EA39

Under bonnet trim - engine cover (SC16/01)

Transaction No.: 2041887/2

Release date: Feb 4, 2016

Figure 2

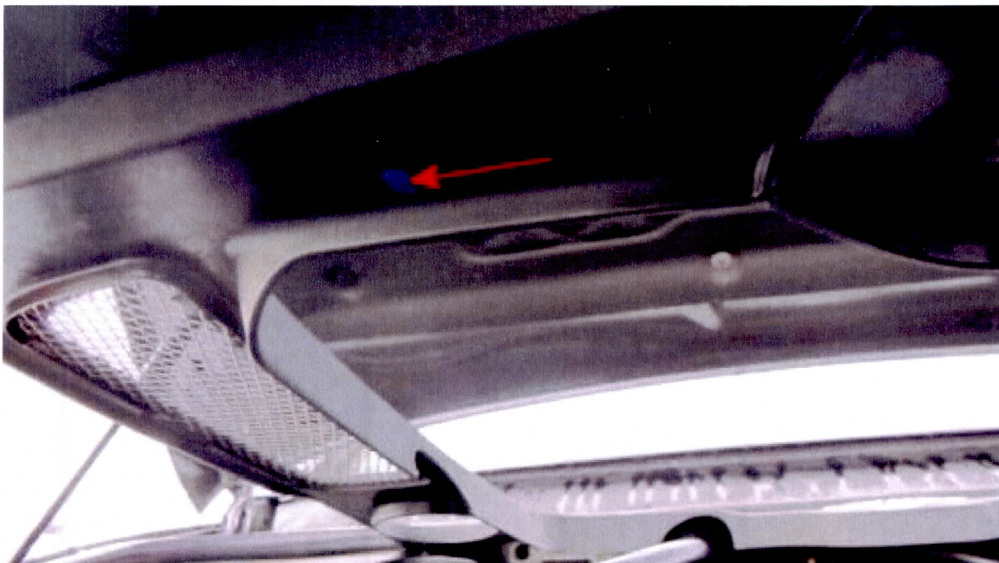
On completion apply a blue identification mark to the underside of the engine cover (see Figure 2)
